13 December 2005

**Re: Tamar and Central Harbour-front
Over-Capacity in Roadway Provision**

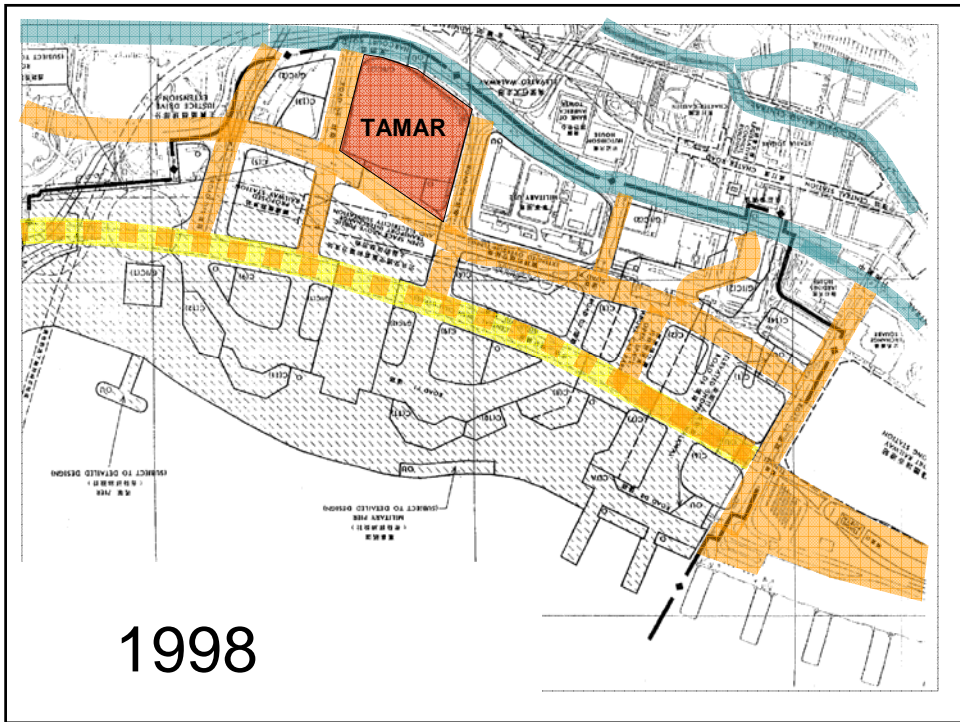
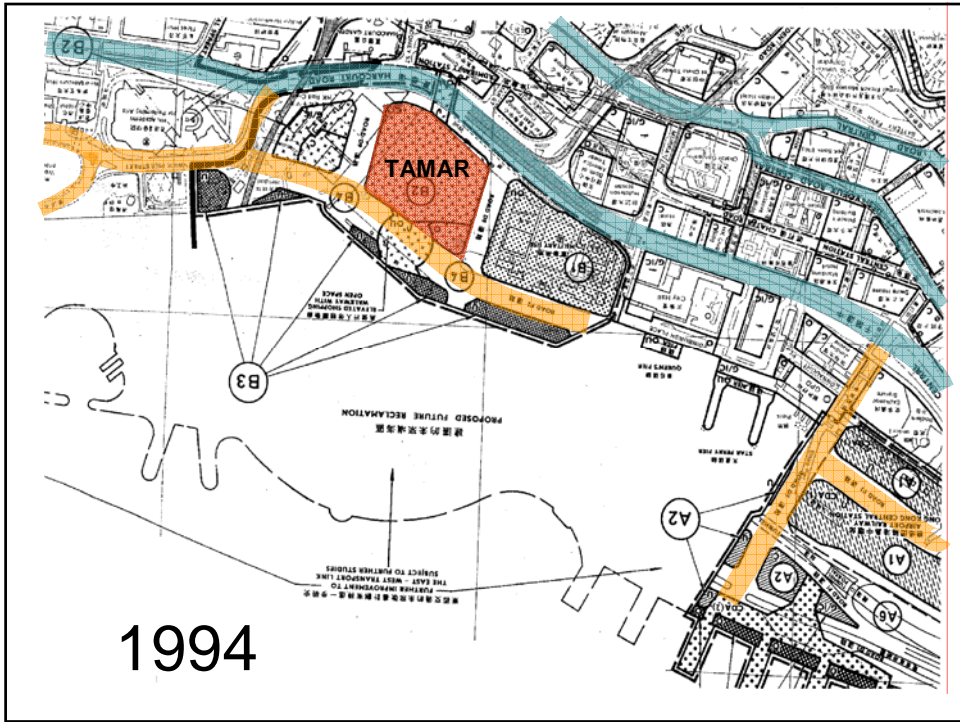
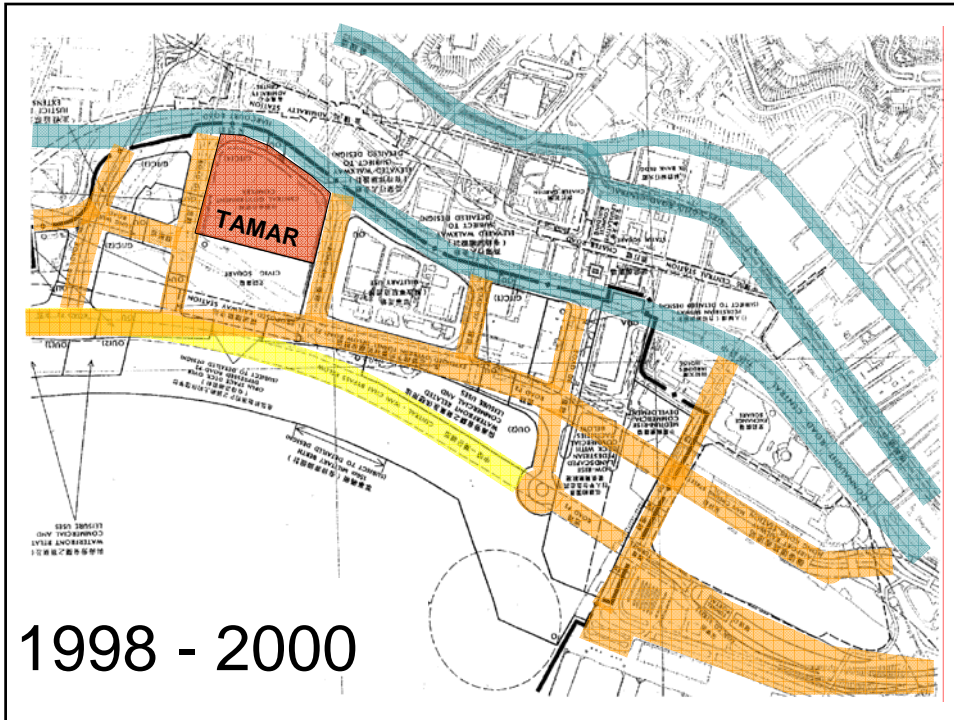
The extent of the P2 and feeder roads that cover the CRIII site is still reflective of the original Metro Plan intentions and not of the current needs of the area. The capacity of the remaining roads is still the same as they were in 1998 even though demand has been considerably reduced through reductions in development. The relative percentage of harbourfront land used for roadways has therefore increased dramatically when it should have been cut in proportion to the building development there.

New road capacity is the same as it was in 1998; however occupation densities have been reduced with land and construction reduction, reducing demand on those roads. Why therefore do we need those same roads?

Roads designed to serve development planned in 1998 will still be constructed today, even though the buildings they were planned for no longer exist

We request that Legco should question deeply the proposed over-capacity and over-provision of surface roads in the CRIII area. Stop and Think. Request a full review of roadway provisions in light of CURRENT development plans and projections. Maximise land use for Public Open Space, not for redundant roadways.
